Access Compliance Report

Public Rights-of-Way

Intersection ID: 49558	Main Street: STEEL_YARD_CT	Cross Street: WARREN_BURGESS_LN	Location: W
ADA ID: 9BD1BC6197A2	Ramp Type: BlendTrans1	Initial Pass/Fail: Fail	Overall Compliance: No
		Severity Score: 10

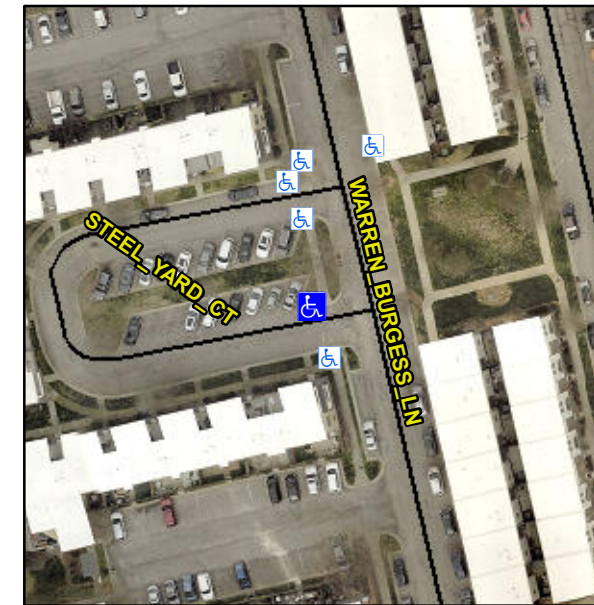
R304.5.1, R304.5.3

Compliance	Description	Data	Compliance	Description	Data
N/A	Ramp Length (in)	60.0	Yes	BlendTrans Slope (%)	4.5
No	Ramp Width (in)	46.0	No	BlendTrans XSlope (%)	4.1
N/A	Flare Type LT	N/A	N/A	Flare Type RT	N/A
N/A	Flare Slope LT (%)	N/A	N/A	Flare Slope RT (%)	N/A
N/A	Flare Traversable LT?	N/A	N/A	Flare Traversable RT?	N/A
N/A	Landing Length (in)	N/A	N/A	DWS Provided?	N/A
N/A	Landing Width (in)	N/A	N/A	DWS Contrast?	N/A
N/A	Landing Slope (%)	N/A	N/A	DWS Length (in)	N/A
N/A	Landing X Slope (%)	N/A	N/A	DWS Full Width?	N/A
N/A	Landing Curb? (Y/N)	N/A	N/A	DWS Offset (in)	N/A
N/A	Shared Landing?	N/A			
N/A	Gutter Ponding?	N/A	N/A	Gutter Slope (%)	N/A
N/A	Gutter Lip Ht (in)	N/A	N/A	Gutter X Slope (%)	N/A
N/A	Painted X Walk1?	Yes	N/A	Painted X Walk2?	N/A
	X Walk 1 Direction	To SE		X Walk 2 Direction	N/A
	X Walk 1 Width (in)	51.0		X Walk 2 Width (in)	N/A
	X Walk 1 Slope (%)	2.3		X Walk 2 Slope (%)	N/A
	X Walk 1 X Slope (%)	1.8		X Walk 2 X Slope (%)	N/A

Remove & Replace Curb Ramp With Two New Directional Ramps or Equivalent.
